Re: *Barbara Crow et al., v. Hometown America, LLC, et al.*, Case 18-cv-12149-LTS
Completion of Stormwater Management System Improvement Projects
Oakhill Settlement Agreement, Section III.C.3 (Doc. 171-1, filed May 6, 2021)

FIELD REPORT #7

Client:	Hometown Oak Hill	Report Date:	December 22, 2020
Project:	Site Observation	A&M Project #:	1830-10
Location:	92 & 93 Such Drive	Contractor:	n/a
Weather:	Rain	Temperature:	40°
Date of Site Visit:	December 14, 2020		
Time:	From: 9:45 am To: 10:15 am		
Present at Site:	Phil Cordeiro (A&M), Peter Conant (Hometown America)		
Reported By:	Phil Cordeiro		
Attachments:	Onsite photograph report

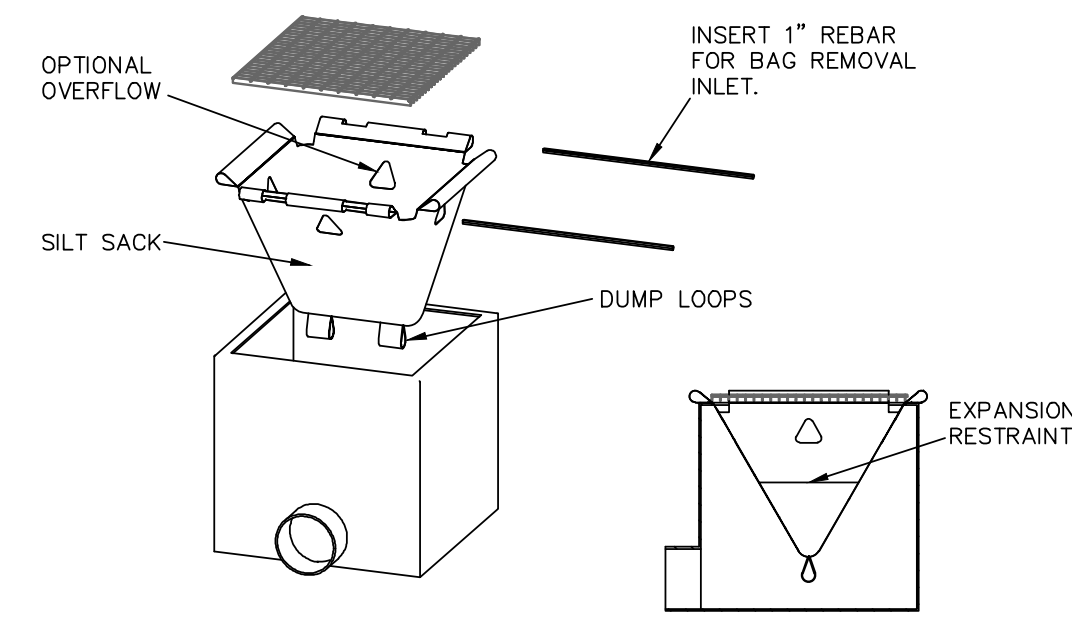
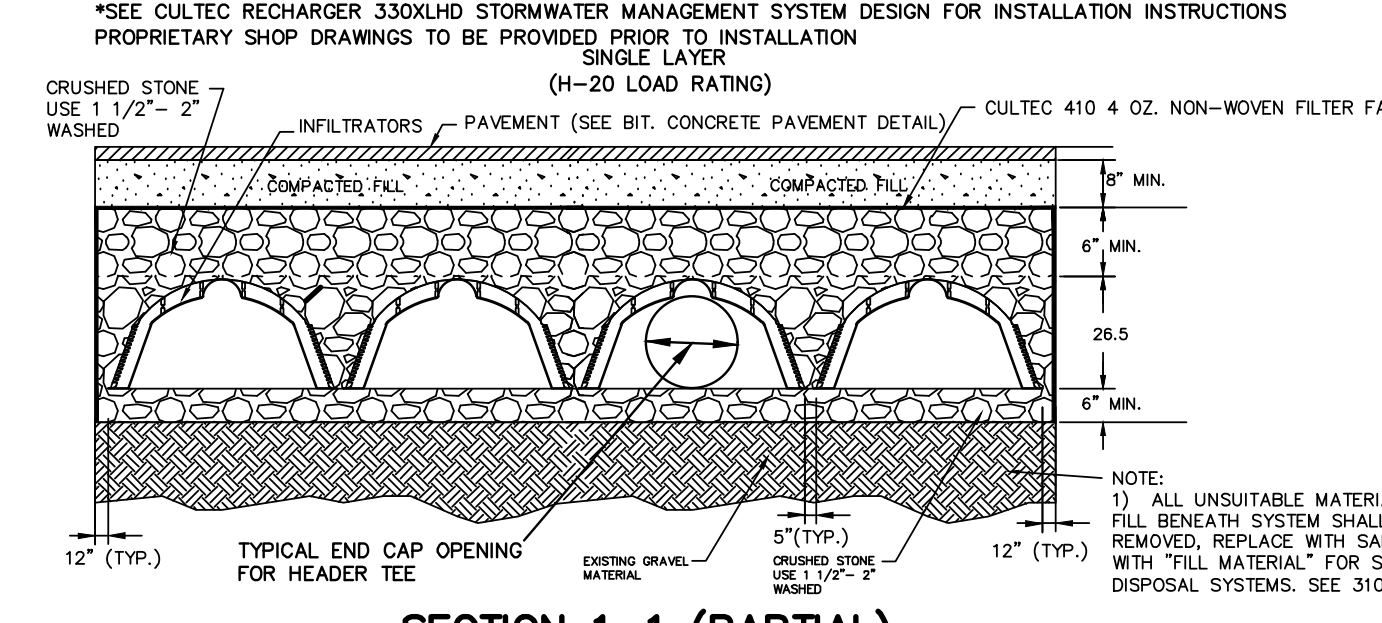
Attached herewith are two photos provided by the contractor SLT which document the construction of the system in compliance with the Construction Plan titled Drainage Improvement Plan, last revised 1/5/21 prepared by Kelly Engineering Group, Inc. (KEG). The two photos included show the completion of the system with stone encasement and filter fabric.

KEG was not on site for the entire construction of the drainage system however did perform a site visit on 1/21/21 to inspect the bottom of the recharge system for soil conditions.

During that site the contractor had excavated to approximately elevation 140.5 which is the proposed bottom of the system. KEG found old top soil that was silty at this elevation. KEG then instructed them to dig approximately 6" deeper where a sandier material was found. A little deeper well drained sands and gravels were found.

KEG instructed SLT to remove the 6" of old top soil from elevation to 140-140.5 to remove the restrictive layer to help recharge better. KEG also requested they provide 4 spots within the system to provide plunge pools or wicks top better infiltrate down to the well drained sands and gravels. Photos were requested to document the system construction.

From the site inspection, photos provided and shop drawing submittal the drainage system appears to be constructed in substantial compliance with the construction plan.

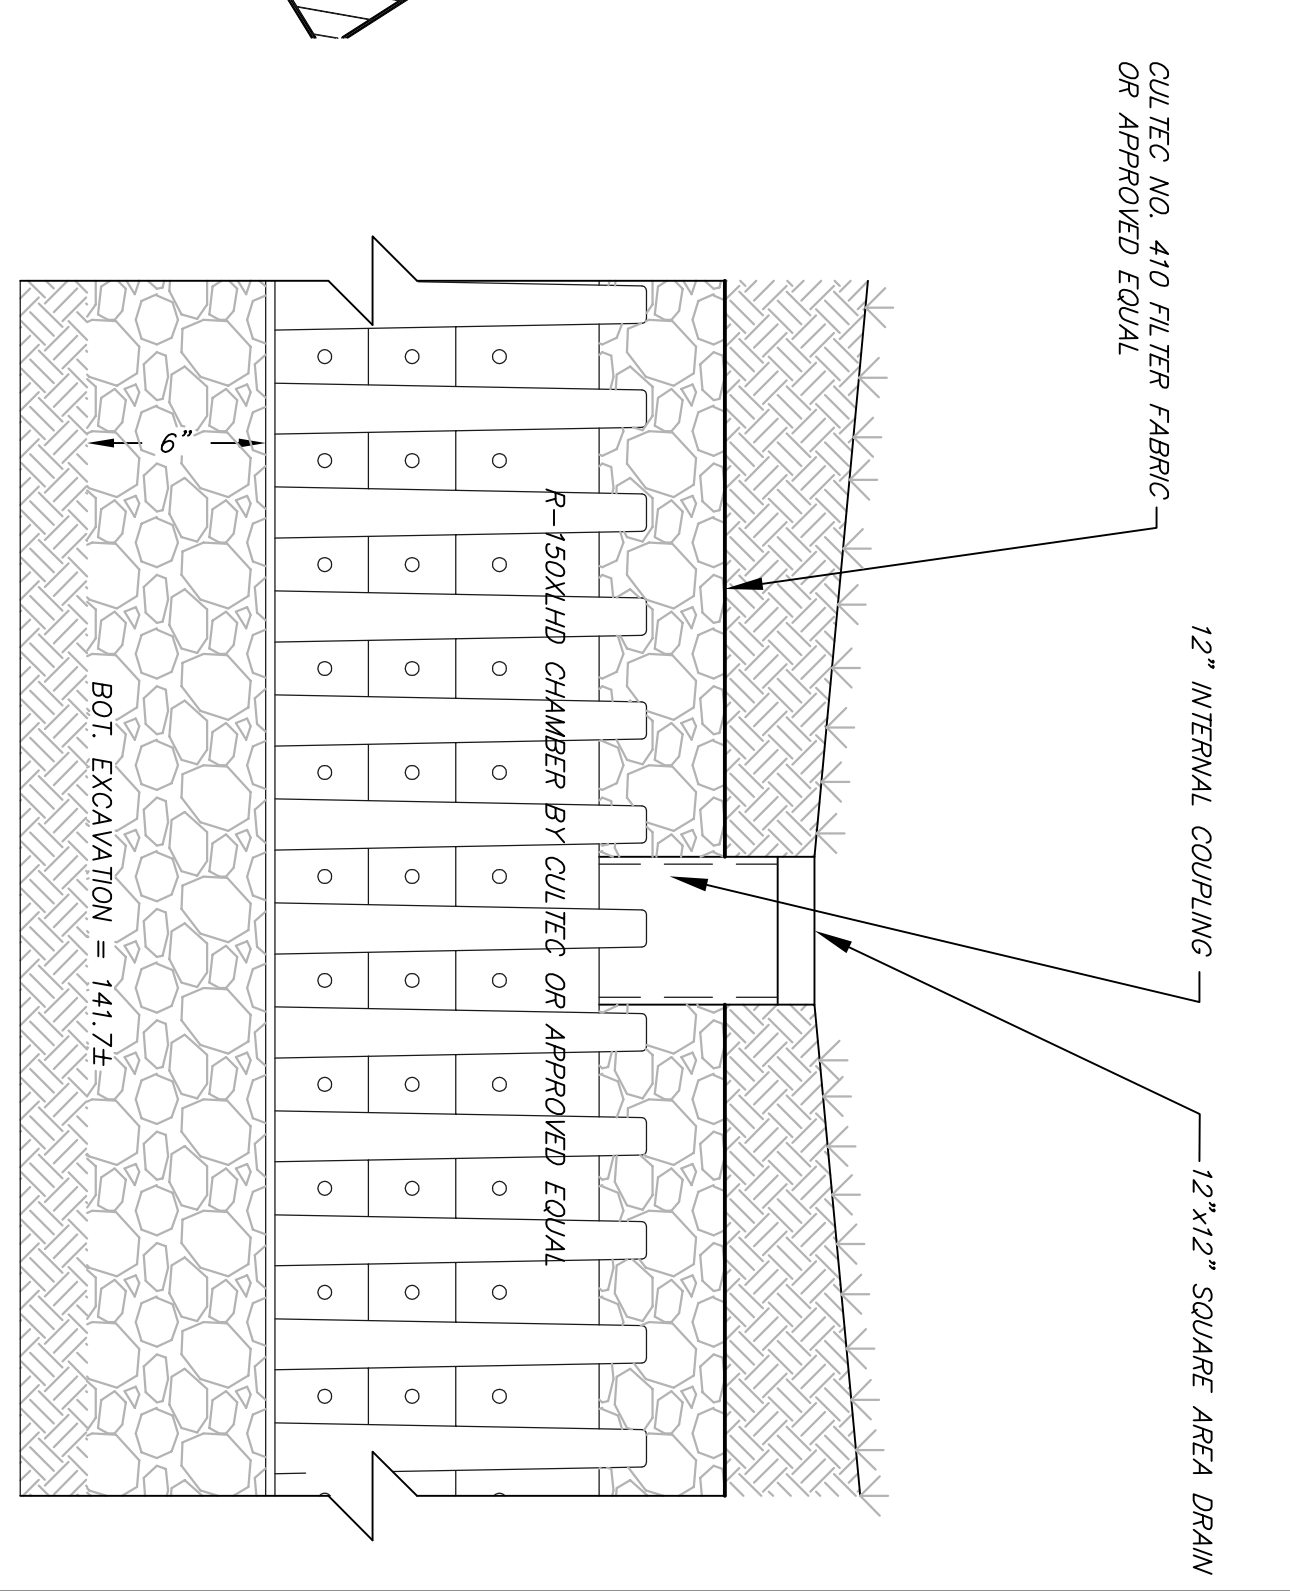
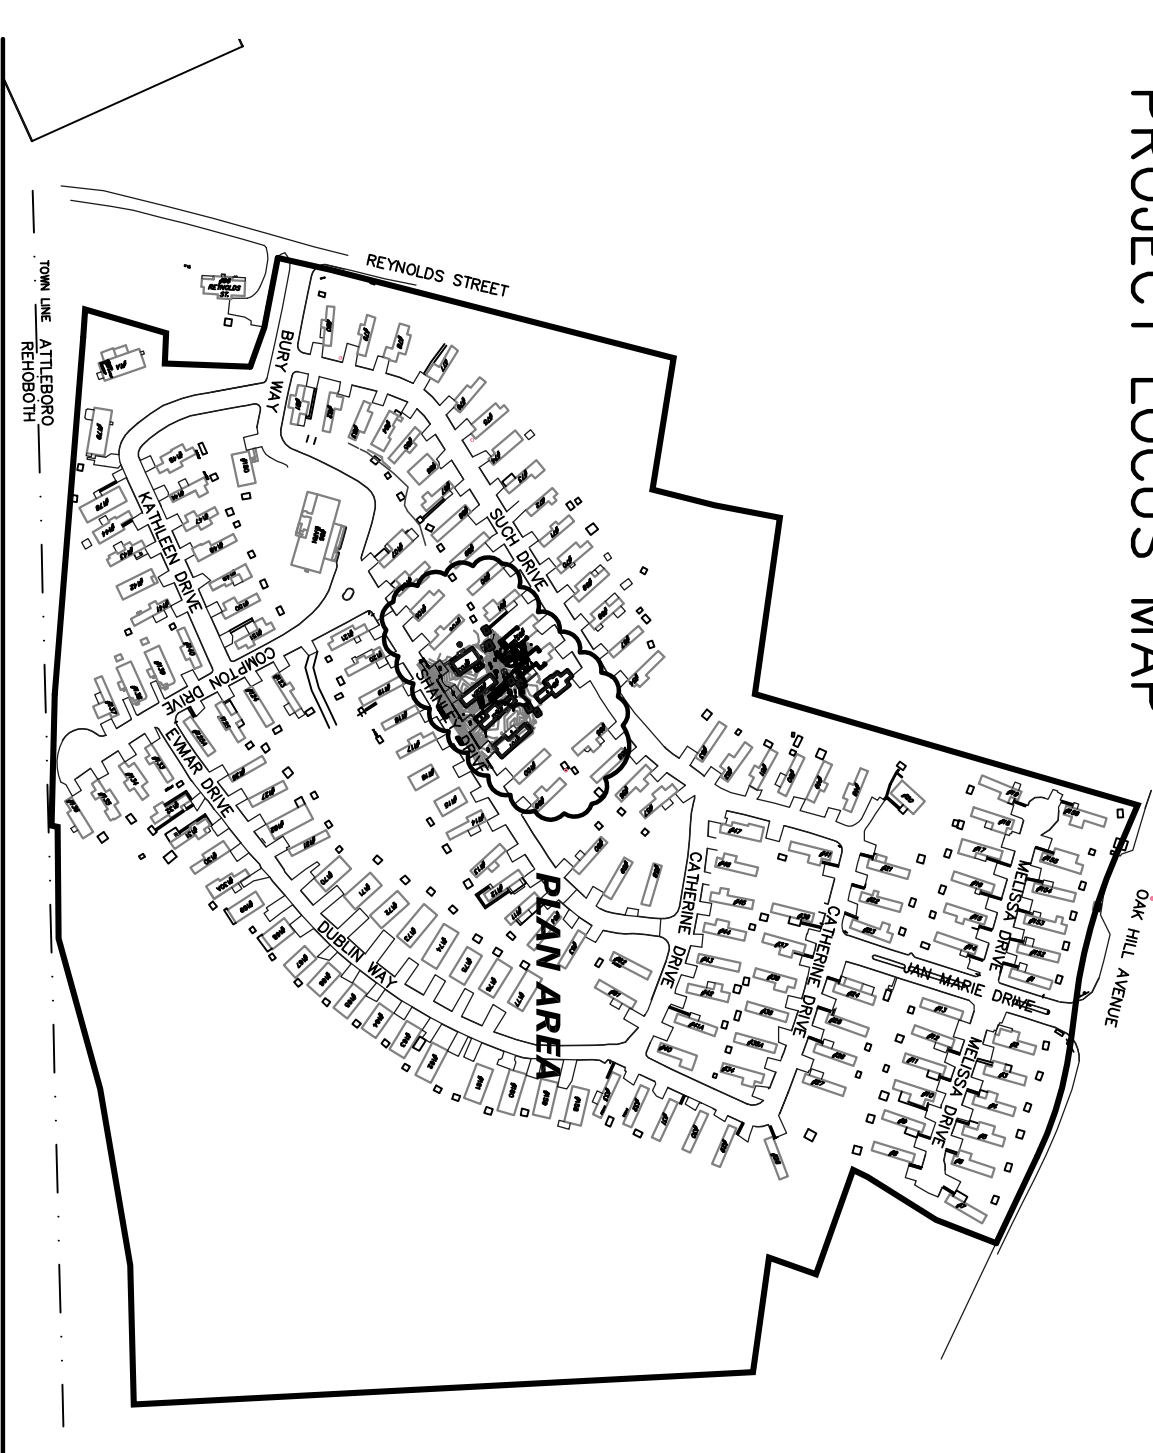
A&M was requested to review the home sites at 92 & 93 Such Drive at the Oak Hill Community in Attleboro, MA. The purpose was to render a determination as to whether the use of a proposed infiltration field as shown on a plan entitled "Proposed Grading Plan for Oakhill residential community" dated May 25, 2018 as prepared by DeCelle-Burke-Sala engineers was appropriate and necessary for this location. The infiltration field was not installed as noted on the referenced plan.

In reviewing the proposed design plan, A&M infers that the Cultec chambers would provide an opportunity for water to collect at a native low point and allow accumulation and recharge below the surface. A&M agrees with this process in principle. However, the current onsite conditions would not adequately convey water to the low point and without further consideration, the addition of subsurface chambers would be costly and ineffective.

A&M observed no detrimental puddles or collection points in the yard area that lead to a conclusion of loss of use or adverse condition. The grass growth, while entering hibernation, appeared strong and healthy and would not be in the observation condition if exposed to repetitive oversaturation. It is possible however that the mismanagement of the home's roof stormwater gutter system has resulted in a redirection of water flow that would in fact create a puddle. Without proper remediation of the gutters, A&M cannot make this determination.

The addition of subsurface chambers can assist in the relocation of water to an unused area. At the discretion of the park, these chambers can be installed, but the upstream areas should be addressed at the same time. Low points in the topography should be eliminated and sloped with the land in a uniform manner toward the low area. The gutter systems should be adequately addressed to direct water toward the landform as it slopes away from any structure. Alternatively, the gutters can be directly piped into the subsurface field. This would eliminate the need for surface topography manipulation and relocate the primary source of water runoff in this area.

The record plan provide by Decelle-Burke-Sala does not quantify the rate of recharge of the stormwater or the effective groundwater elevations where the system is proposed. A&M did not make any determinations relative to the design parameters used as they were not stated on the plan. An effective method of determining soil adequacy is to conduct a shallow test pit and perform an infiltration test to determine the soils ability to absorb water.
